URBAN DESIGN CONSULTATION RESPONSE

Design Officer	Azhar Kapadi
Date	22.12.25
Application Reference	25/00798/FUL
Address	Jamia Masjid Chashtiah Mosque, 49 - 53 Milkstone Road, Rochdale, OL11 1EB
Proposal	Redesign of the front elevation including alterations to fenestration, erection of 4.8m high minaret to roof. Installation of solar panels and the application of white render to both front and rear elevations

Scheme Image(s)

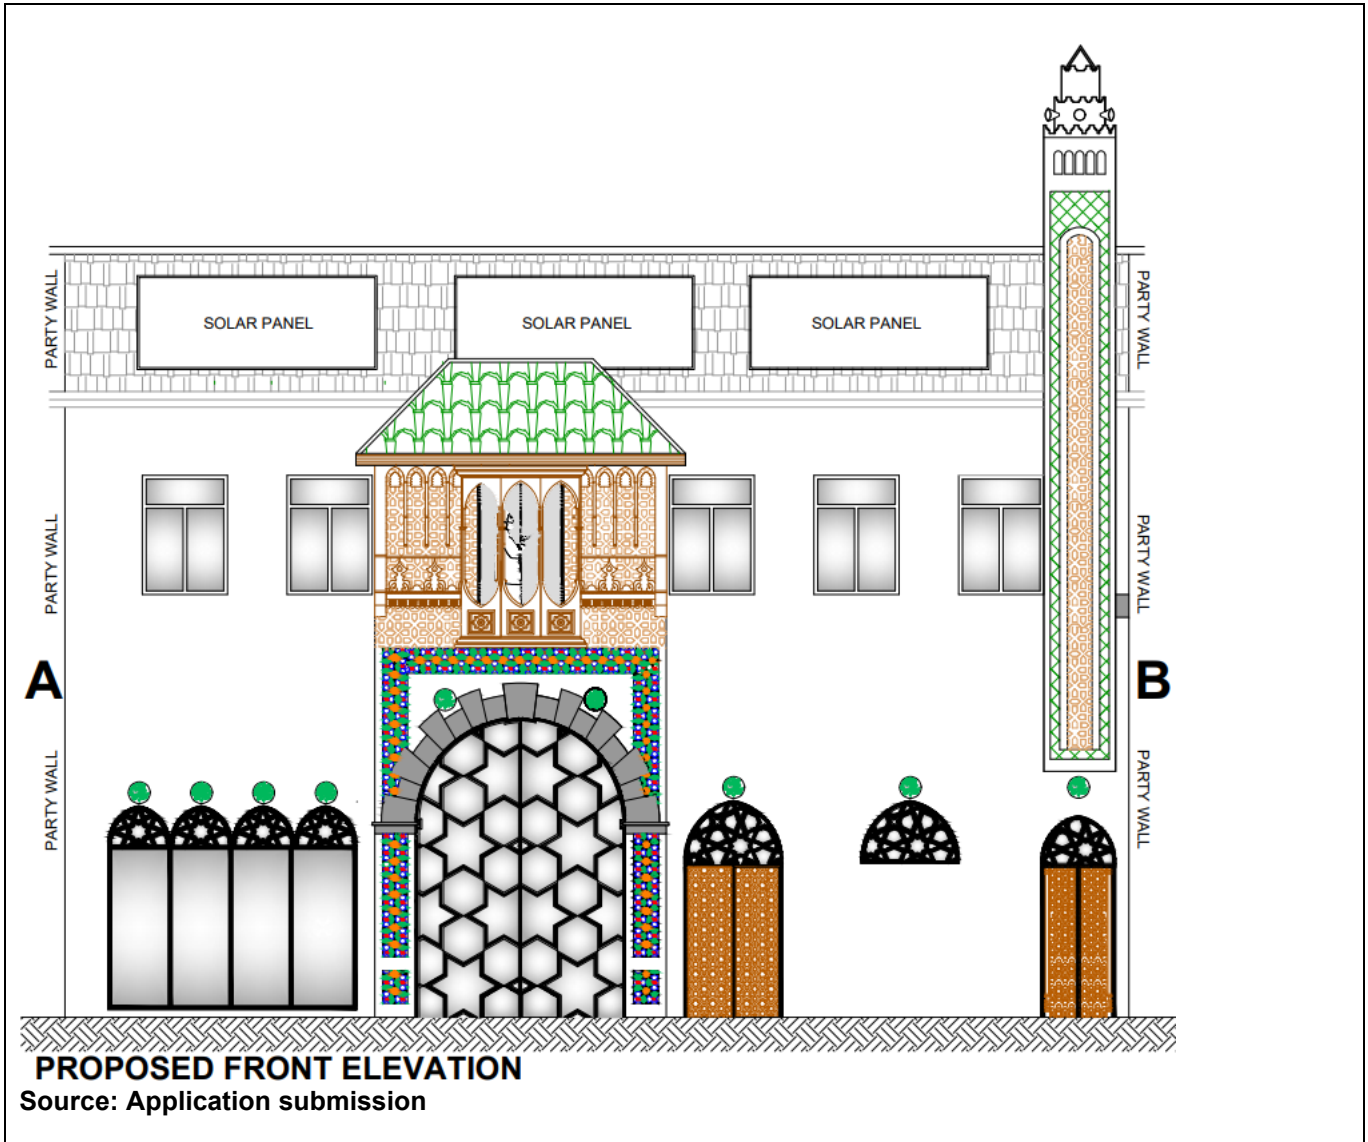
The plans and elevations do not align i.e. windows shown incorrectly.

Turning to the design itself, the proposal appears to mimic a North African mosque typology, resulting in a literal pastiche that sits uncomfortably within its context and does not build upon the positive features of the existing building. The wholesale removal of the brick façade through extensive render, together with the omission or downgrading of window details, horizontal banding, lintels and cills, suggests an attempt to replicate Moroccan-Andalusian architecture rather than respond to the local streetscape. This reflects a missed opportunity to draw on relevant precedents and the more successful elements of the surrounding context.

Beyond the diluted treatment of existing features, the design overcompensates with superficial references; the most prominent example, a mock mashrabiya. This reinforces these concerns and introduces further issues of appropriateness. Based on the material submitted, there is no realistic confidence that the scheme could be constructed to anything approaching the level of craftsmanship implied by the chosen precedent — nor would pursuing that stylistic route be appropriate in this context in any case. Similarly, the proposed minaret, which would likely be unsuitable in this setting,

lacks a coherent scale and proportion in relation to the host building, resulting in an unbalanced composition.

Ultimately, the architectural language is incongruous and lacks coherence, with individual elements on the façade failing to relate meaningfully to one another even before considering the wider street scene. Any future proposal should take proper account of the host building and its status as a NDHA. This is not to suggest that creativity or contemporary expression cannot be introduced; rather, such interventions must be grounded in the building's existing character.
